## **Proposal for Amendment to gtr 3 (Motorcycle Brake Systems)**

### **Submitted by the expert from International Motorcycles Manufacturers Association\***

The text reproduced below was prepared by the expert from IMMA in order to introduce amendments to clarify the text and introduce simplified test procedures in this regulation and align it with R78. The modifications to the current text of the Regulation are marked in bold or strikethrough characters.

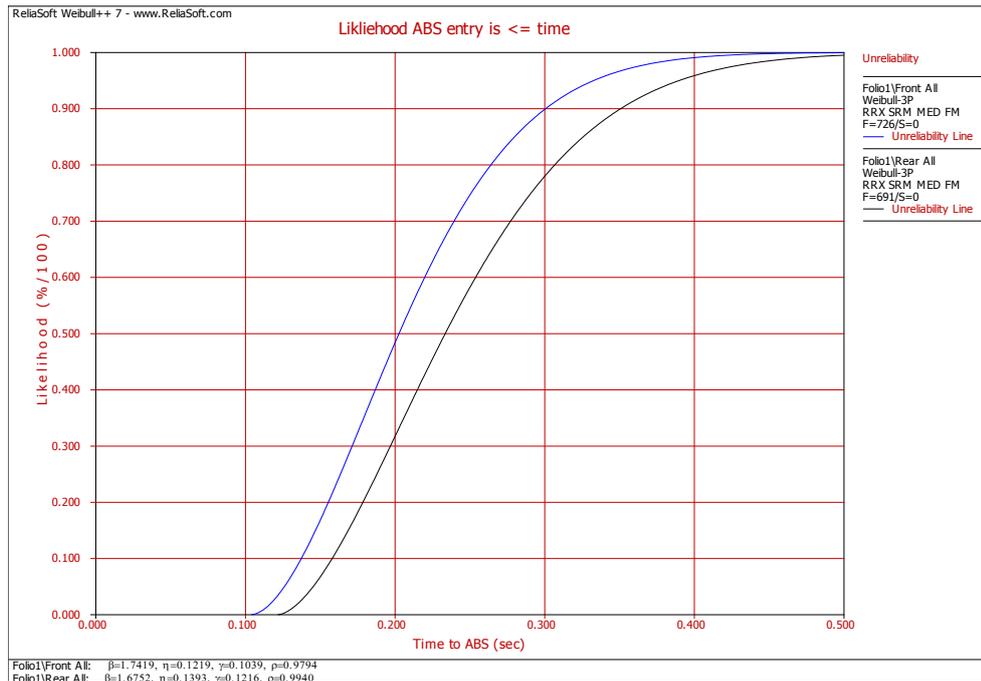
- (f) Brake application rate:  
The brake control actuation force is applied in **0.1** – 0.5 seconds.

It has been noticed in testing that the brake application rate specified in section 4.9.5.1 can result in a large number of test failures. It can be seen in the chart below that the 0.2 second lower limit shows a failure rate is between 30% and 50% of the time.

By reducing the lower limit to 0.1 seconds the test failure rate reduces to practically zero. Allowing the reduction tends to make the regulation more stringent by including a greater number of brake force application rates and eliminates restrictive test requirements.
